ERRATUM No. 1 TO THE ENVIRONMENTAL IMPACT REPORT

TVC 2050 Project

Environmental Case: ENV-2021-4091-EIR
State Clearinghouse No. 2021070014

April 2024

Figure 6
Outdoor Production Activity Areas—Modified Project

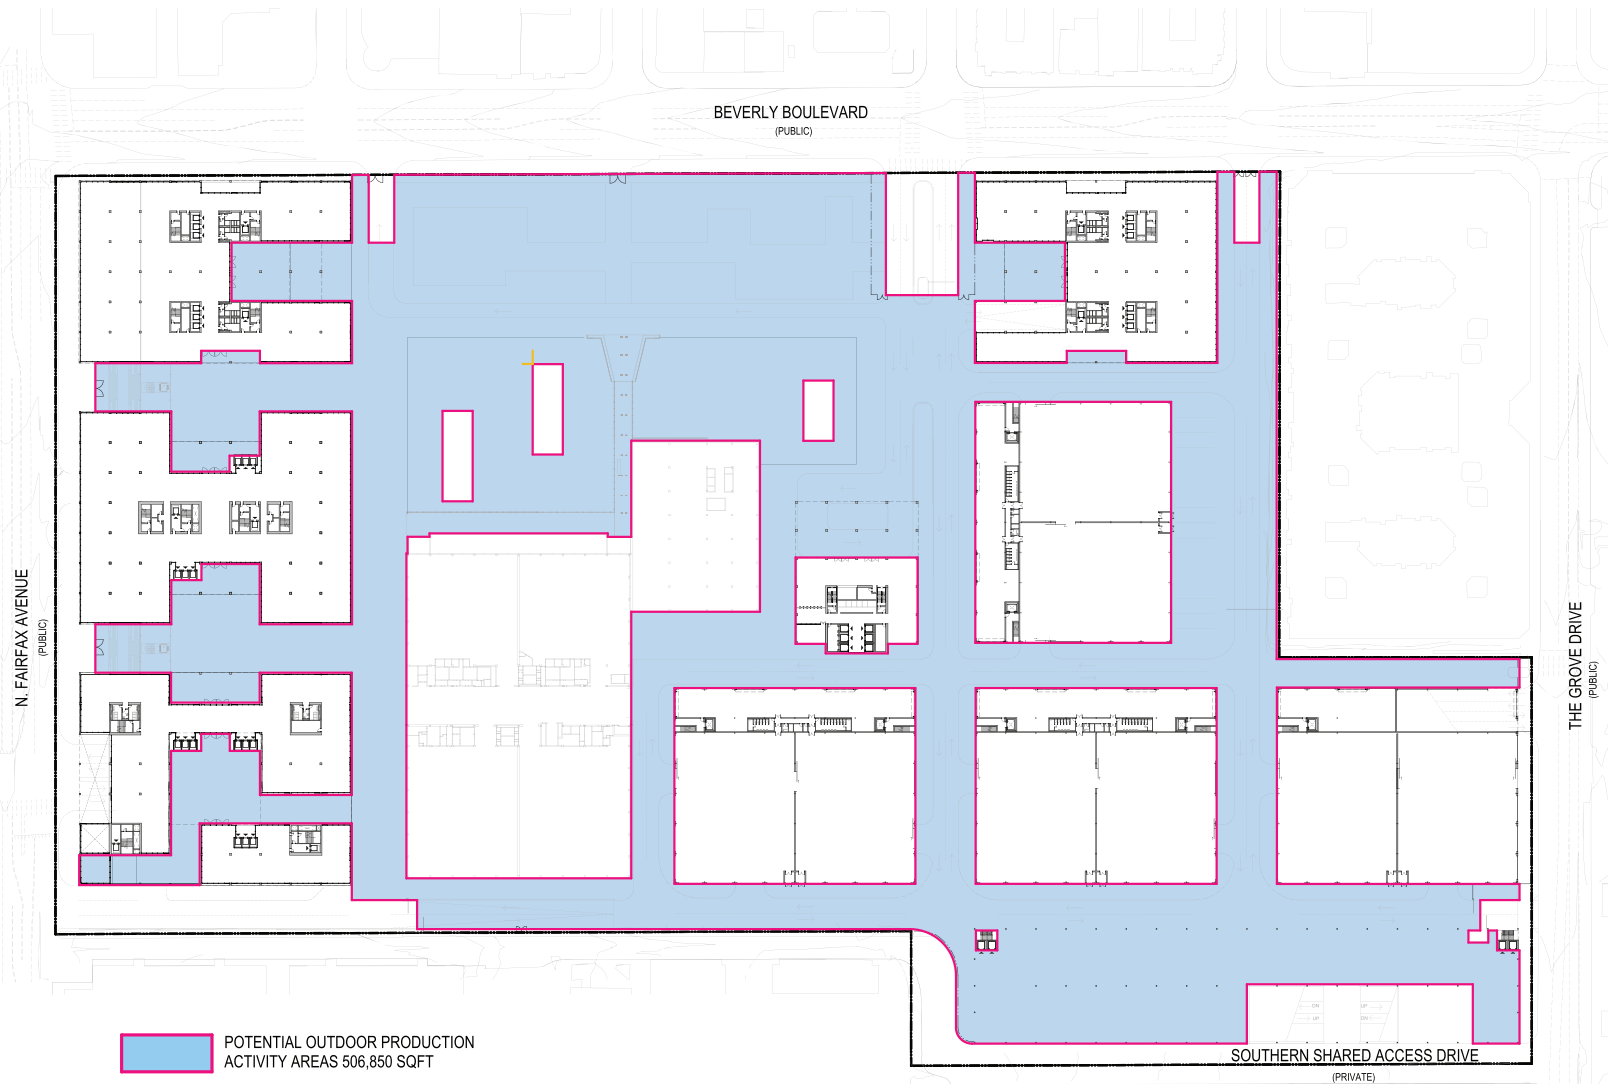
The size of the outdoor production activity areas and basecamp areas under the Modified Project are substantially smaller than the areas under both the Original Project and existing conditions. The locations of outdoor production activity areas under the Modified Project are shown in

Figure 6 on page 12. Under the Modified Project, these outdoor production activity areas comprise approximately 506,850 square feet, a reduction of approximately 79,052 square feet when compared with the Original Project, which included approximately 585,902 square feet of outdoor production activity areas. The Modified Project would result in a reduction of approximately 144,999 square feet of outdoor production activity areas when compared with the existing approximately 651,849 square feet of such areas. The locations of basecamp areas under the Modified Project are provided in Figure 7 and Figure 8 on pages 13 and 14. The Project Grade basecamp areas comprise approximately 125,010 square feet and the below-grade basecamp areas comprise approximately 36,800 square feet, for a total of approximately 161,810 square feet of basecamp areas (a reduction of approximately 209,790 square feet when compared with the Original Project and a reduction of approximately 15,190 square feet compared to existing conditions). The proposed below-grade basecamp areas have been reduced from approximately 144,000 square feet to approximately 36,800 square feet. As shown in Figure 1 on page 7, as with the Original Project, under the Modified Project the helipad would continue to remain within the central portion of the Project Site, but with an approximately 45-foot higher elevation (which results in reduced noise levels as discussed below in

Figure 9
Height Subareas, Setbacks, and Stepbacks—Modified Project

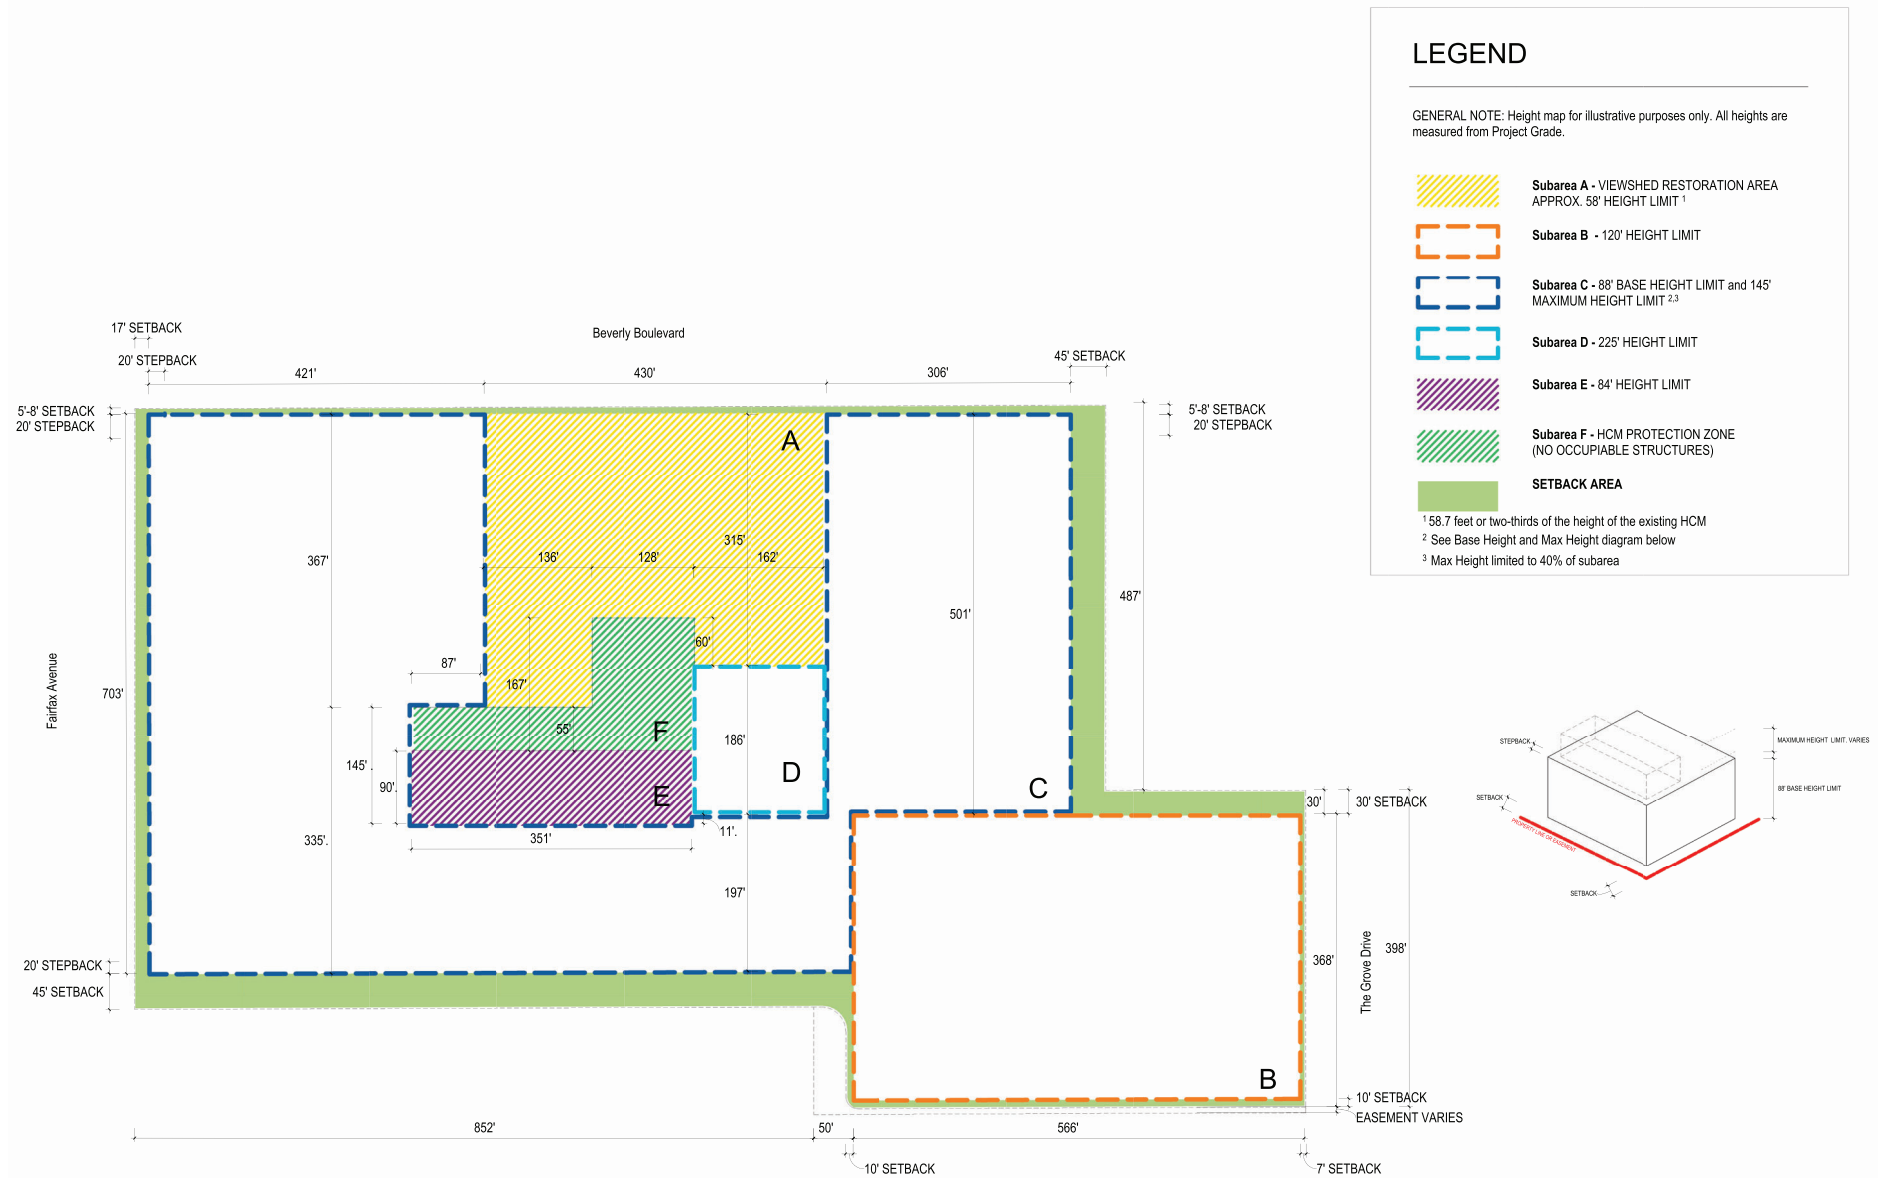
15 feet to 145 feet. In addition, as shown in Figure 9 on page 16, the height limits for Subarea A (Viewshed Restoration Area), Subarea E, and Subarea F (HCM Protection Zone) have been retained.

The Modified Project also proposes increased setbacks and stepbacks. As shown in Figure 9, the 30-foot setback along the Shared Eastern Property Line west of the Broadcast Center Apartments and the 30-foot setback along a portion of the southern property line have each been increased to 45 feet. With the increased setback along the southern property line and the continued required stepback of 20 feet from the setback, the upper levels of the proposed buildings would be located even further from the property line. In addition, the stepbacks for the upper building levels along Beverly Boulevard and Fairfax Avenue have increased from 10 feet to 20 feet.

Figure 11
Illustrative Vehicular Site Access—Modified Project

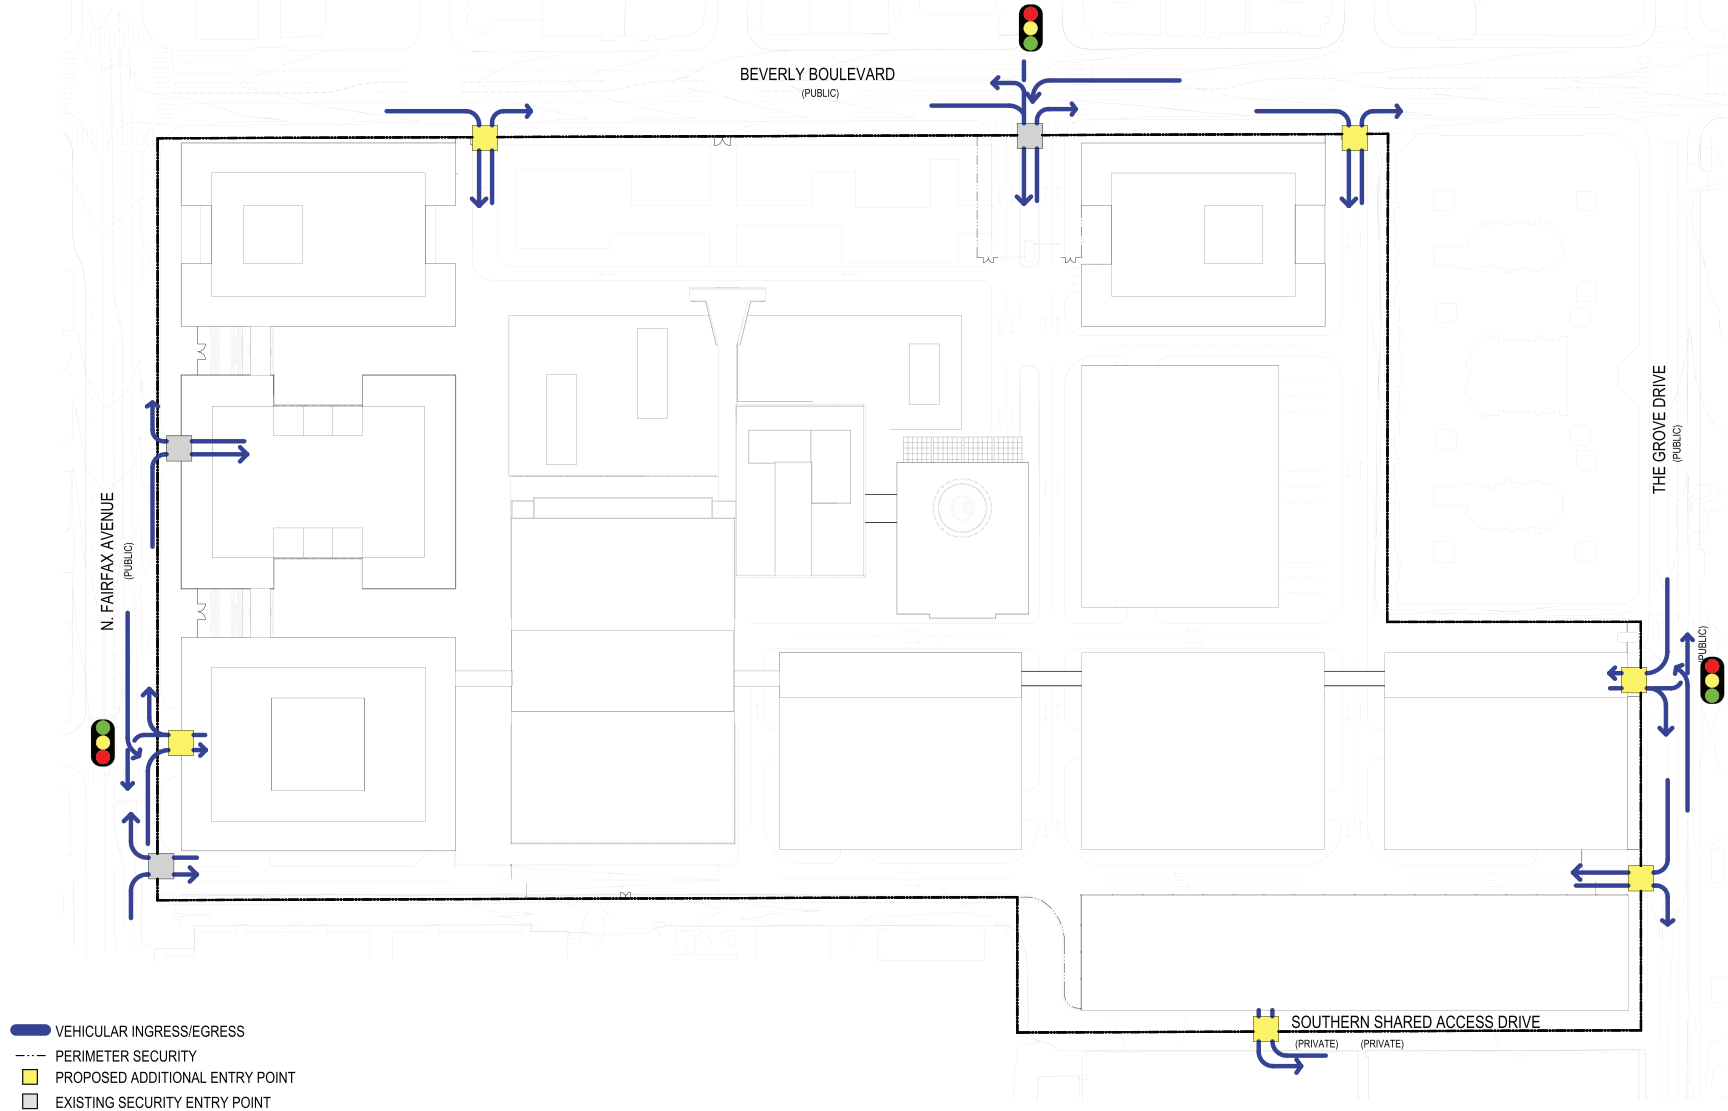
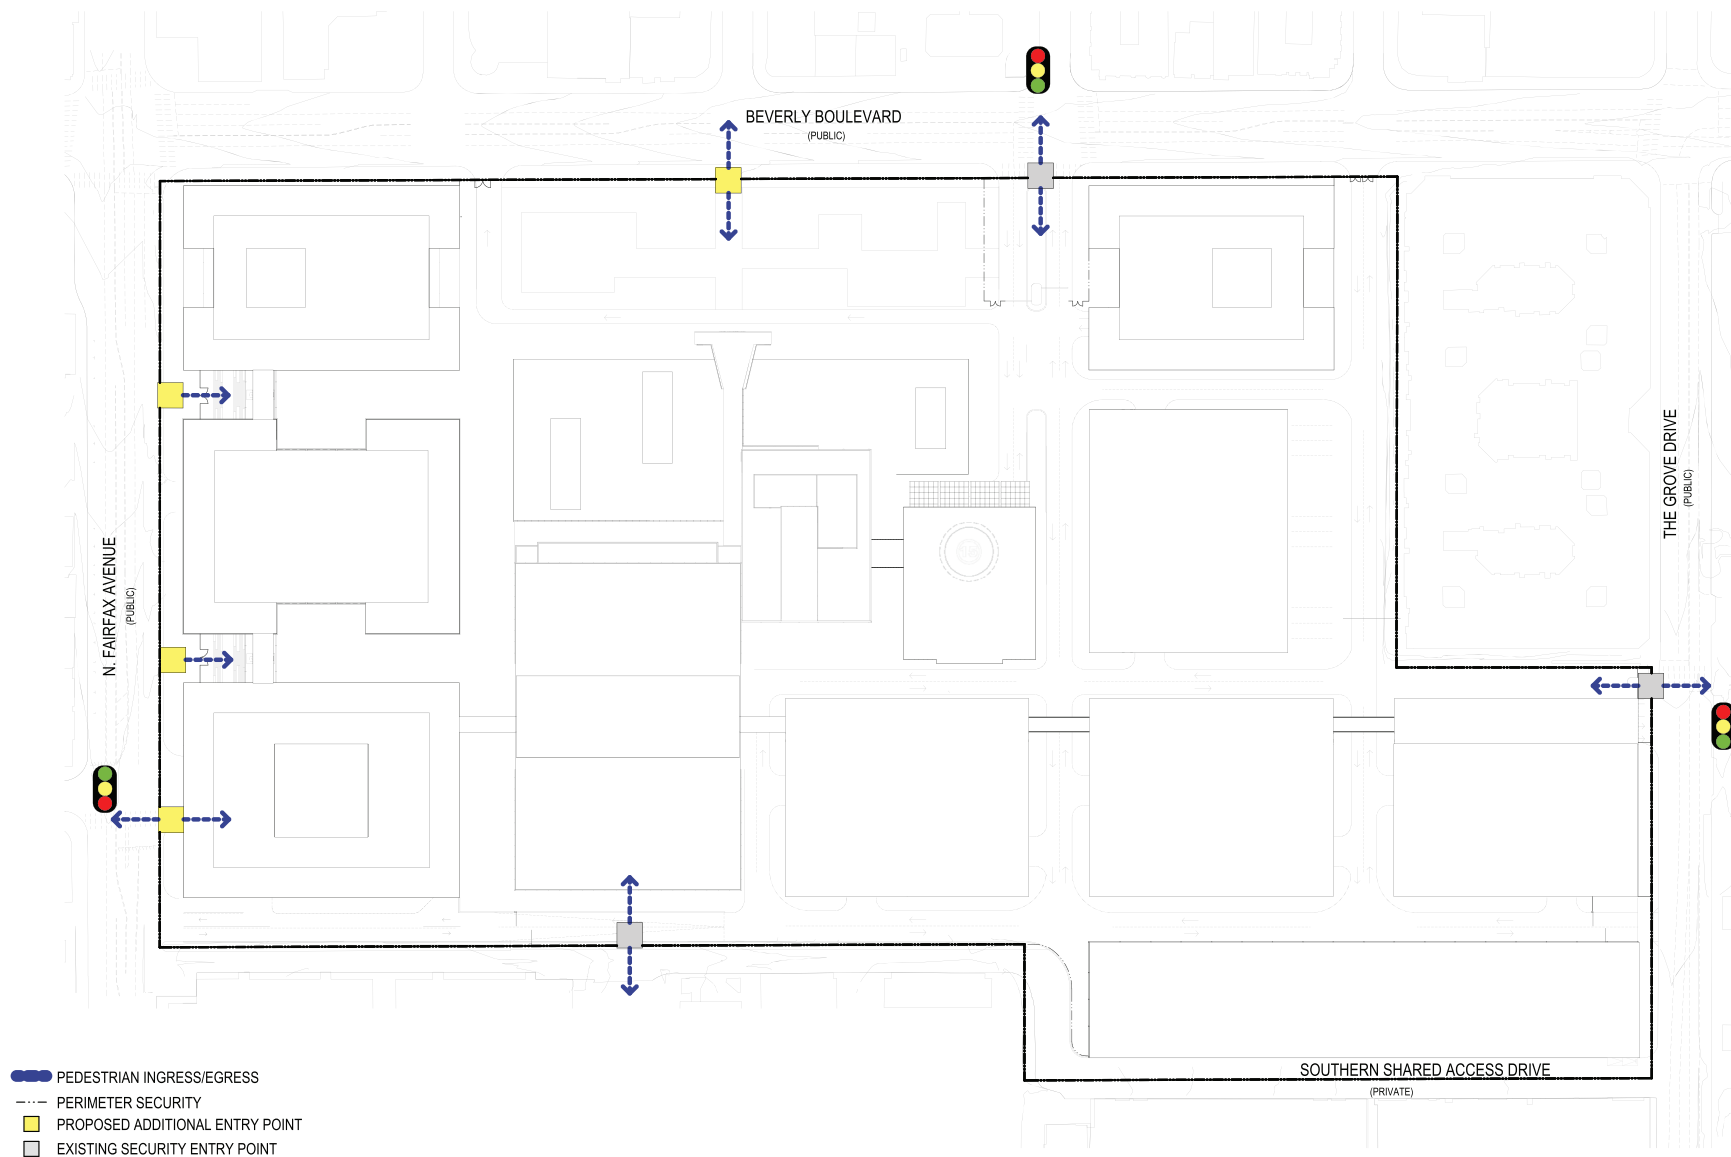
Proposed vehicular and pedestrian access under the Modified Project is depicted in Figure 11 and Figure 12 on pages 19 and 20. As shown in Figure 11, the Modified Project also updates Project Site access and circulation at the proposed signalized driveway on The Grove Drive. This driveway would be narrowed to a four-lane cross section rather than five lanes and would provide access directly to the first subterranean level of the adjacent parking garage thereby eliminating at-grade vehicle circulation adjacent to the Broadcast Center Apartments southern property line. This driveway would only accommodate passenger vehicles (no trucks), reducing the traffic load at the driveway. The security gates would be set even further into the Project Site and, therefore, would provide increased capacity for on-site queuing than proposed in the Original Project, further reducing the potential for queuing on The Grove Drive. In addition, the Modified Project also proposes an additional unsignalized driveway reserved for emergency access and limited truck access on The Grove Drive between the proposed signalized driveway and the Southern Shared Access Drive, clarifying the separation and distribution of vehicles access to the Project Site from The Grove Drive. The Modified Project would also eliminate one of the two proposed driveways on the Southern Shared Access Drive. The remaining driveway would be reserved for emergency access and limited truck access.

Figure 13
 Outdoor Gathering Areas—Modified Project

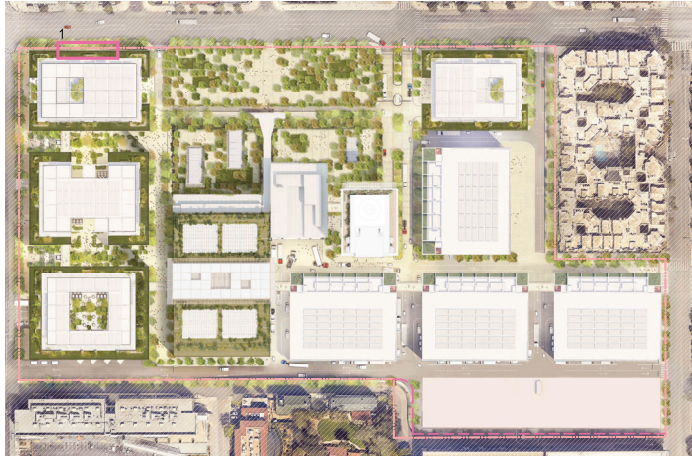
As with the Original Project, some of the buildings under the Modified Project would incorporate rooftop terraces or decks that would serve as outdoor gathering spaces. Figure 13 on page 22 provides an overview of the potential locations of these areas. As with the Original Project, noise limits would be established for any outdoor amplified sound systems used for gatherings (non-production uses) on roof decks.
